APPLICATION FOR
AMENDMENT OF PLAN UNDER SECTION 12A OF
THE TOWN PLANNING ORDINANCE
(CAP.131)

For Official Use Only 請勿填寫此欄	Application No. 申請編號	Y/YL-MP/6
	Date Received 收到日期	15 SEP 2021

**Rezoning from "Residential (Group D)" to "Residential (Group C) 1" Zone
For a Proposed Residential Development at Various Lots in D.D. 104 and
the Adjoining Government Land in Yuen Long, N.T.
S12A Amendment of Plan Application**

**Rezoning from "Residential (Group D)" to "Residential (Group C) 1" Zone
For a Proposed Residential Development at Various Lots in D.D. 104 and
the Adjoining Government Land in Yuen Long, N.T.
S12A Amendment of Plan Application
TPB Ref. Y/YL-MP/6**

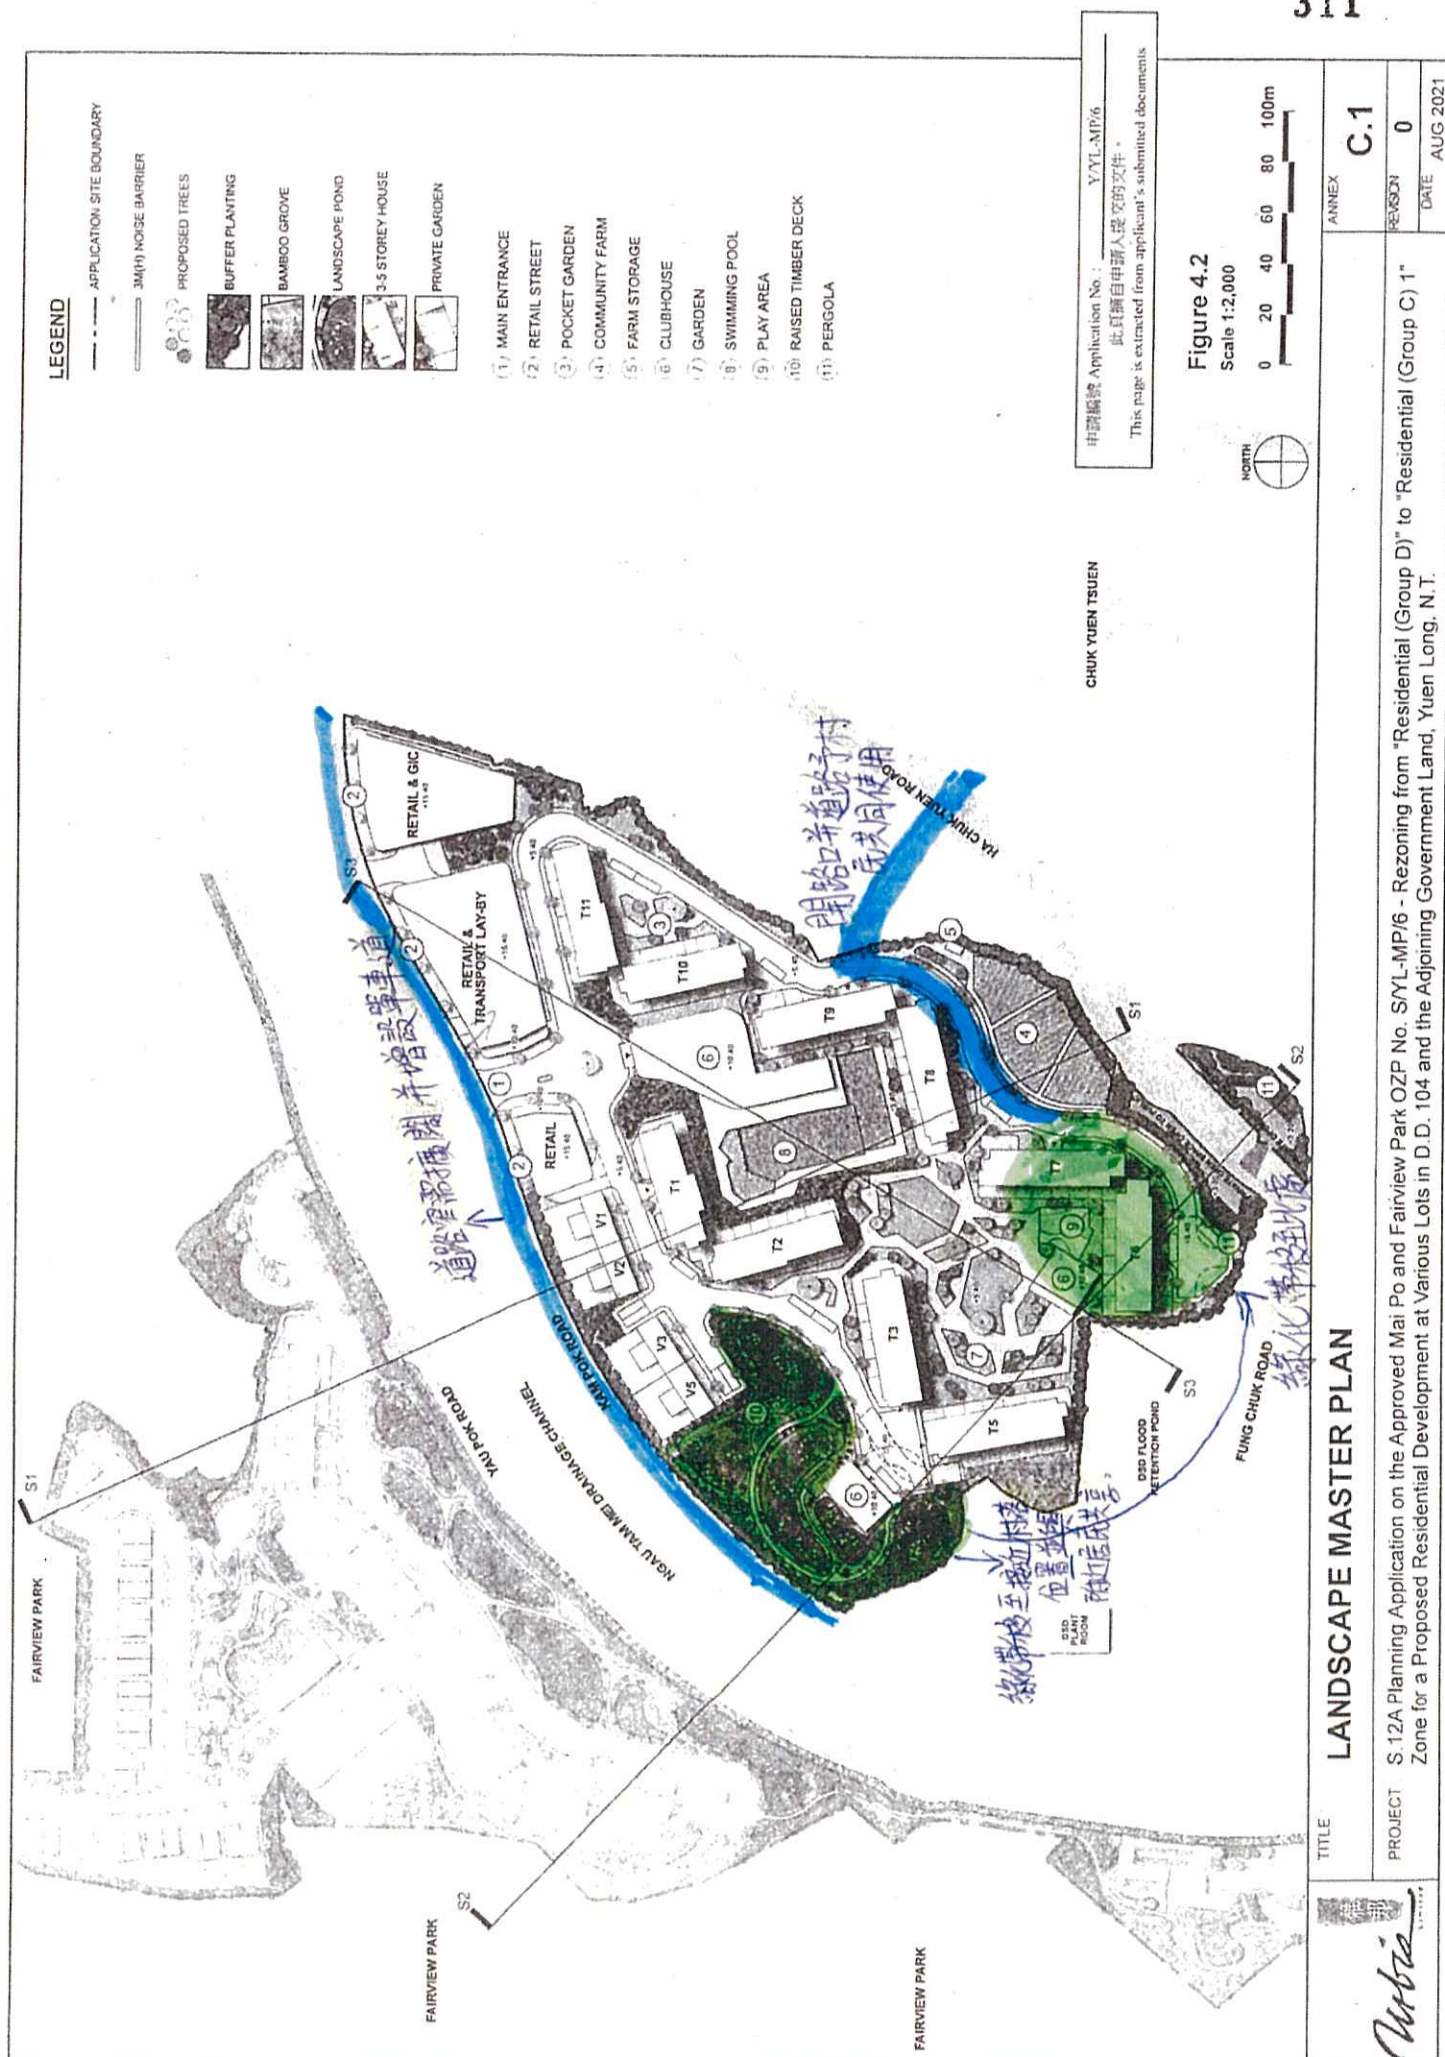
- 1、此申請地點位於錦墾路段，該路段過於狹窄，故地盤發展範圍需收窄，用之擴寬道路，並增設單車徑。(附圖藍色線條示)
- 2、要求將地盤發展成低密度的三層住宅。新田鄉所屬地區大部分環境均以低密度開發，地積比例都是在零點四或以下，周邊樓宇的高度發展都是局限於三層，若高於此規格，將會遮擋周邊住宅的現有開放景觀。
- 3、於發展地段所用到的主要交通要道其中有錦繡迴旋處，但此地作為元朗交通要道，交通堵塞問題已存在已久，問題尚未解決，若再發展高層住宅，增加大量人口，祇會對交通堵塞問題雪上加霜！
- 4、因附近綠化地及休憩地緊缺，故此發展範圍內的綠化及休憩地帶應從現時規劃位置遷移至接近附近村落位置，並與附近居民共享。(附圖綠色線條示)
- 5、要求發展屋苑需於範圍內開設一條道路予附近村民共同使用。(附圖示)

Figure 1. Distance between the application site and WCA.

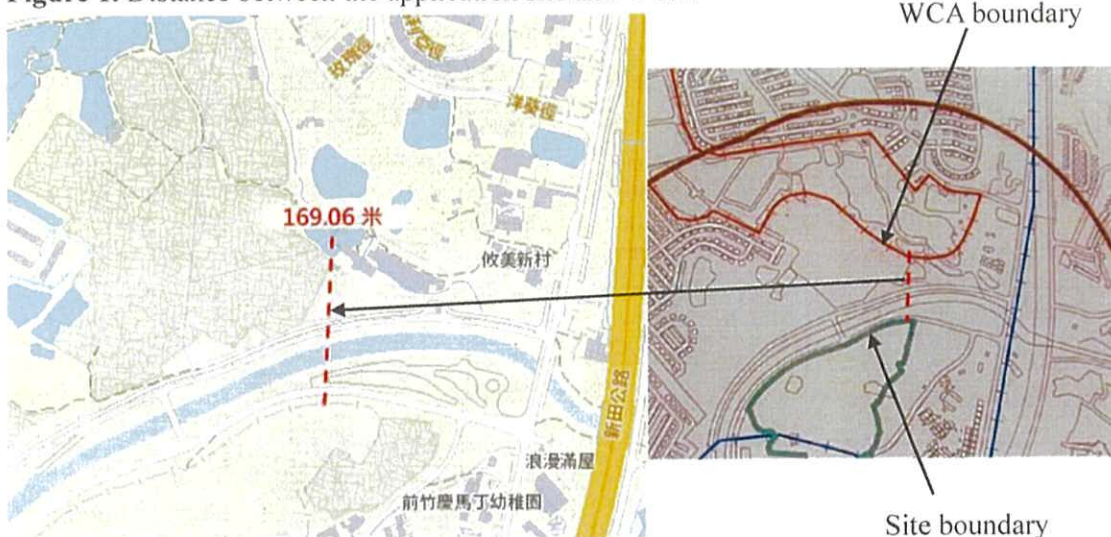
5. While we cannot quite understand how the application site can be considered to be ‘close to’ the future ‘development node of the NOL at NTM’, we would like to again point out that the site is now located less than 170 m from the WCA and next to wetland habitat of moderate ecological importance (i.e., NTMDC; see later explanation). Also, we would like the Board to look at the photomontage extracted from the gist and reproduced in **Figure 4** of this letter, as well as the on-site conditions as shown in **Figure 3**. We urge the Board to consider whether the proposed development, with 10 high-rise blocks ranging from 16 to 23 storeys and several blocks from 3 to 5 storeys, can be considered to be compatible (or ‘not incompatible’) with the existing surroundings, and whether the addition of trees or plantings could help to integrate the proposed high-rise blocks (i.e., max. 23 storeys) with the surroundings.

Figure 3. On-site photos taken in October 2021.

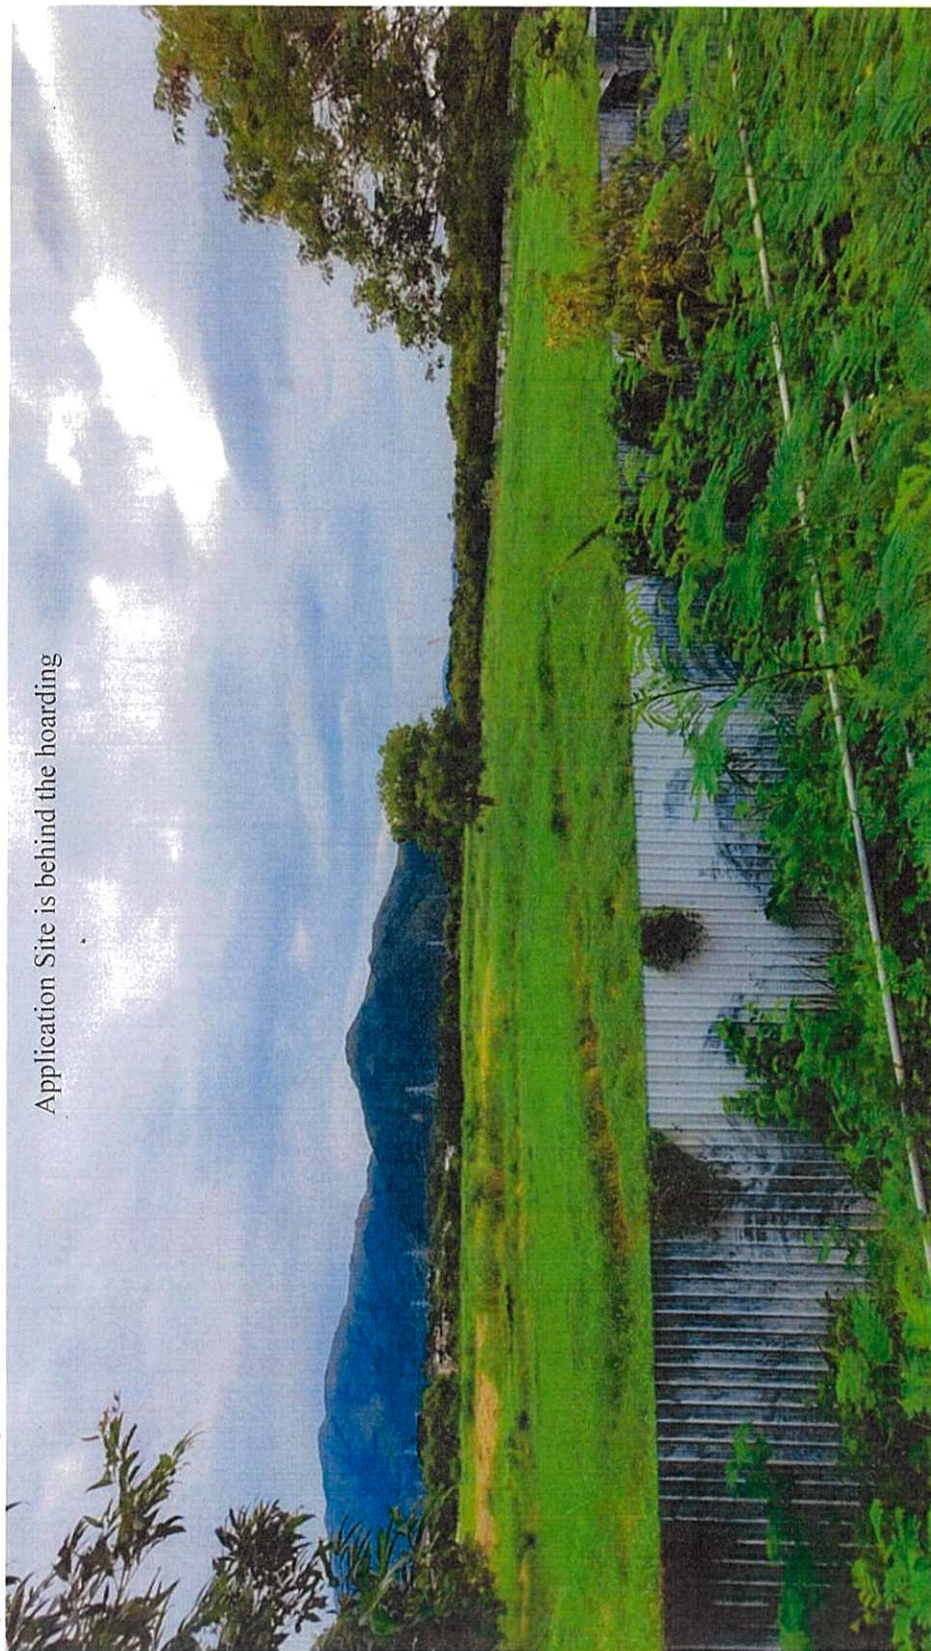
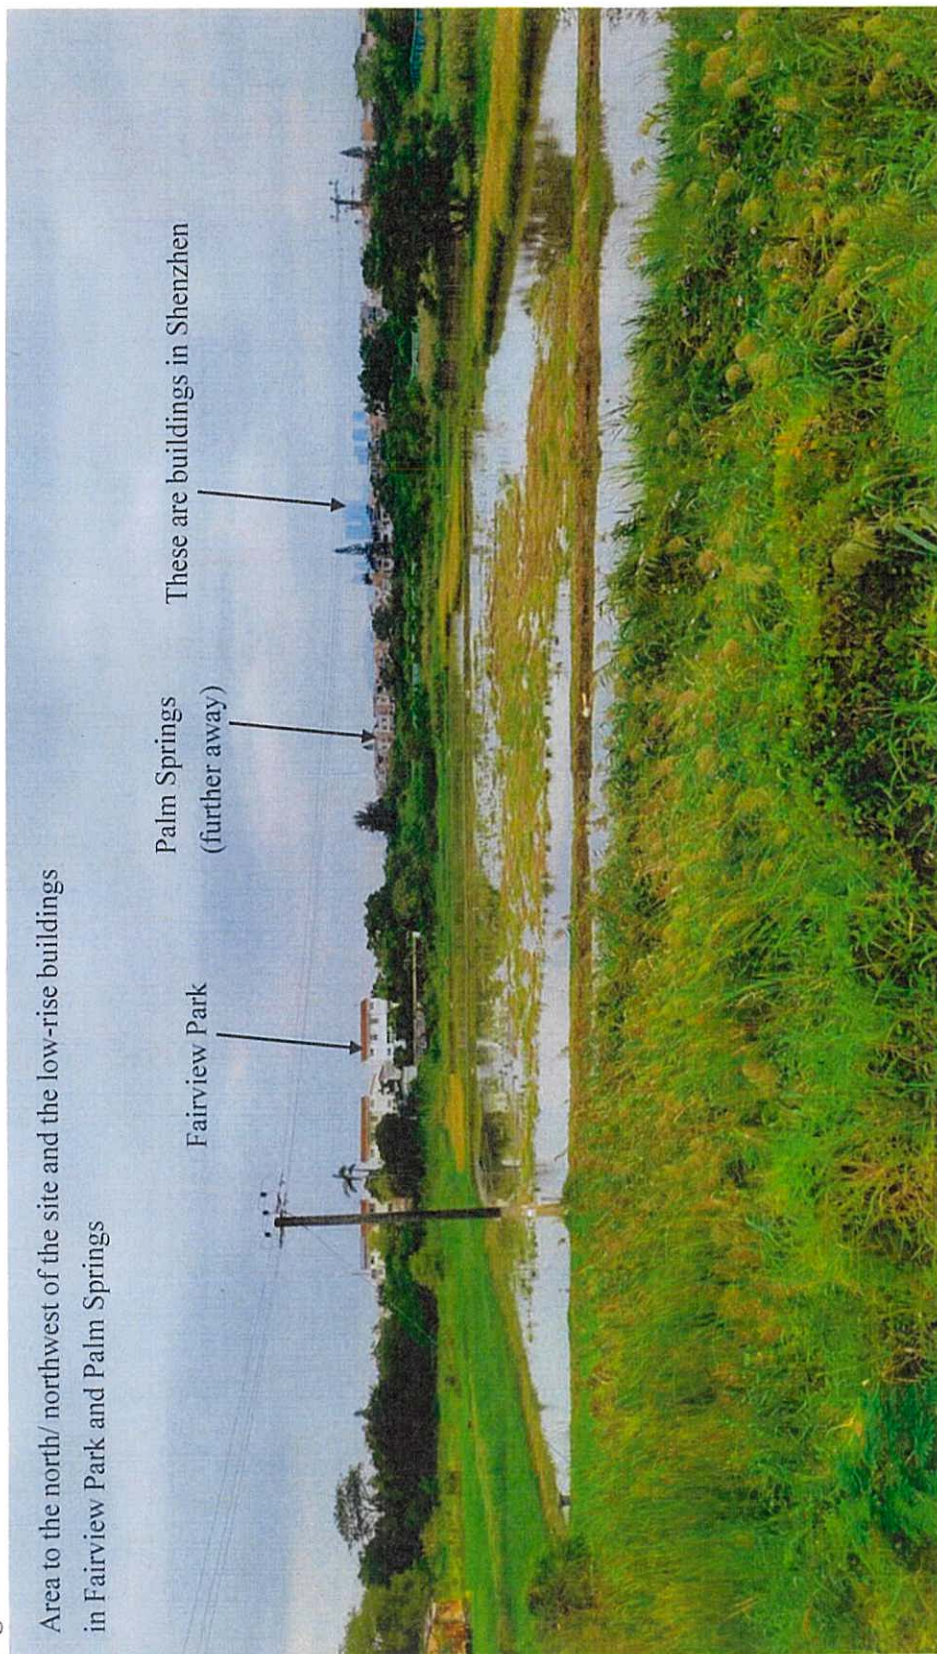
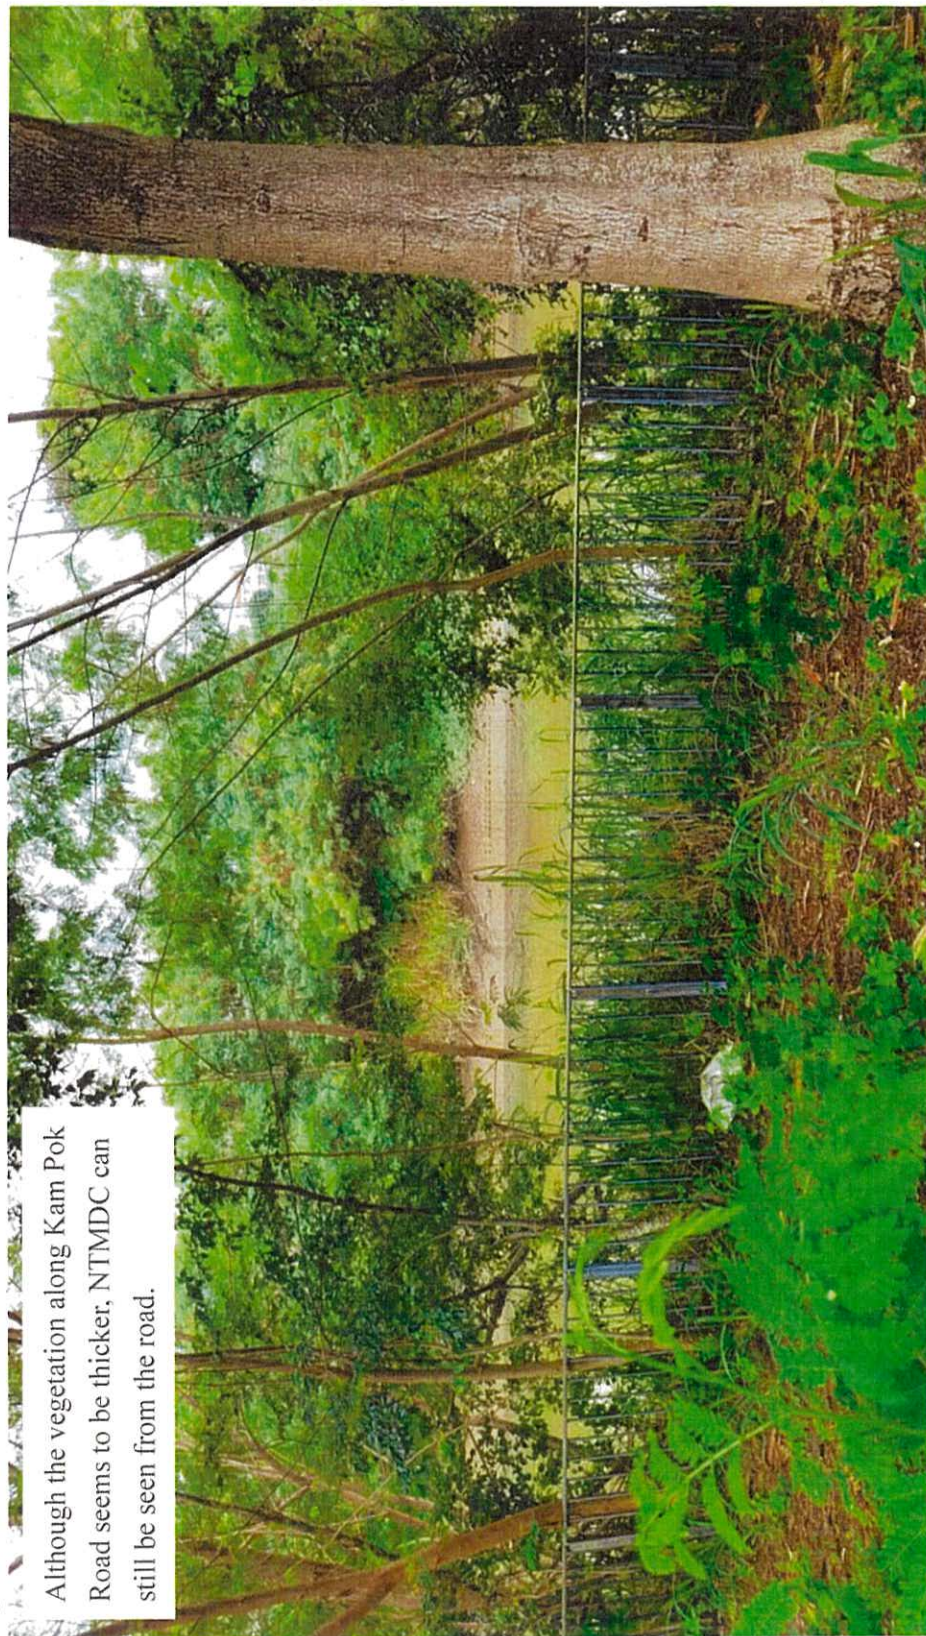
disturbance (e.g., 4, 5) (see also a photo in **Figure 3**). While one of the key concerns would be how long the disturbance distance is, the approved Environmental Impact Assessment (EIA) for the Sheung Shui to Lok Ma Chau Spur Line has provided that the exclusion distance (where a species is precluded from using the area because of the impacts from the station and railway) of BFS is 100 m, and the maximum distance of reduced density ranges from 150 to 200 m⁶; also, this approved EIA has considered the overall disturbance sensitivity of BFS to be ‘high’⁶. In addition to this EIA, there is also a scientific study (published in 2015) examining the response of wintering BFS to disturbance⁷; this study states that:

Kam Pok Road and
pedestrian road next to the
site; are they heavily used?

Figure 1. Flocks of wild ducks and Black-faced Spoonbill utilising the NTMDC section close to Y/YL-MP/6, observed on 30th January 2023.

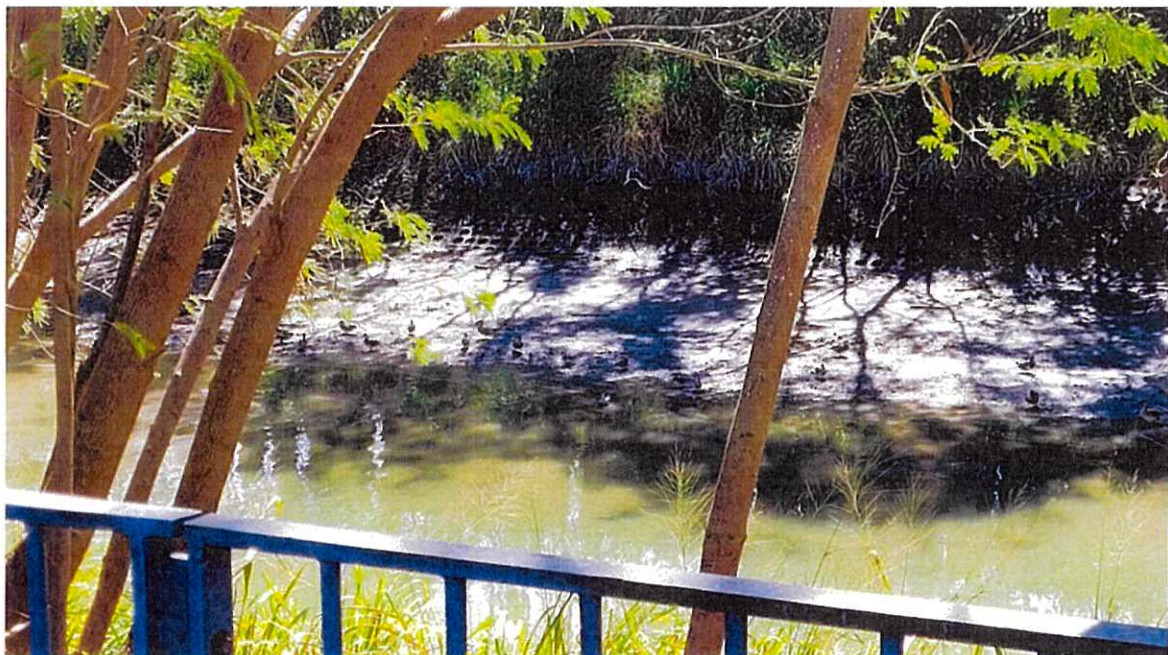
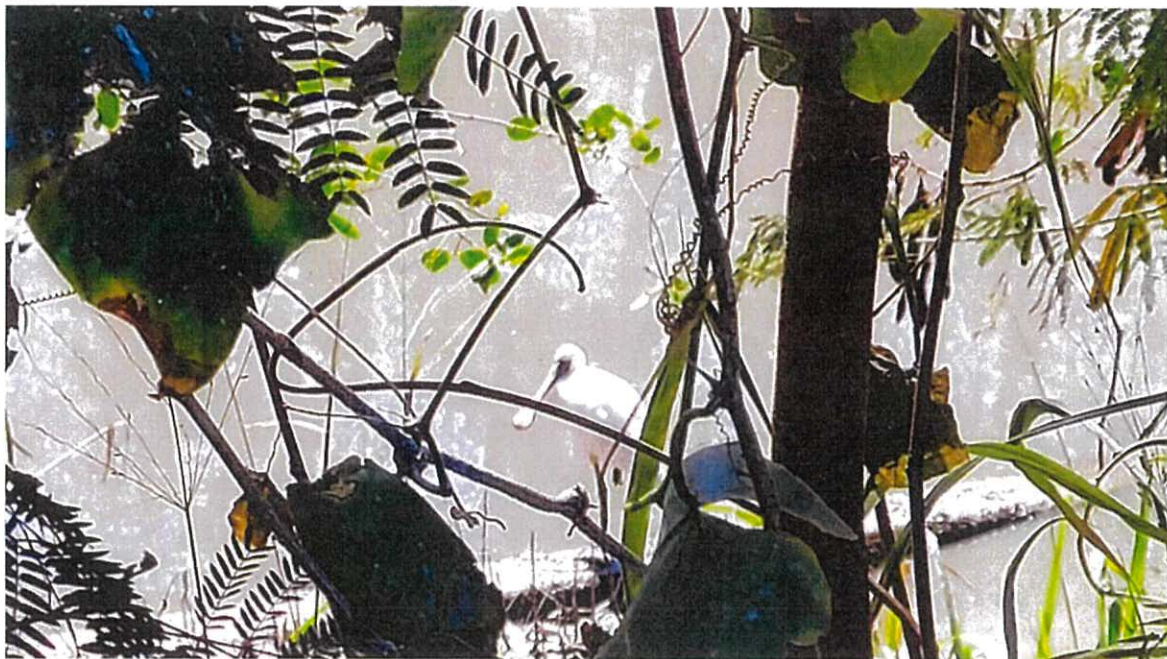
1. We refer to the captioned.
2. We in general maintain our view and our previous submissions are attached to this letter (after **Figure 1**). But we would also like to share with the Board our latest observation from the Ngau Tam Mei Drainage Channel (NTMDC); please see **Figure 1**. As shown, flocks of wild ducks and Black-faced Spoonbill could still be observed in January 2023 from the NTMDC; this indicates clearly that NTMDC is a wetland habitat regularly visited by many wetland bird species, not occasionally.
3. Thank you for your attention.
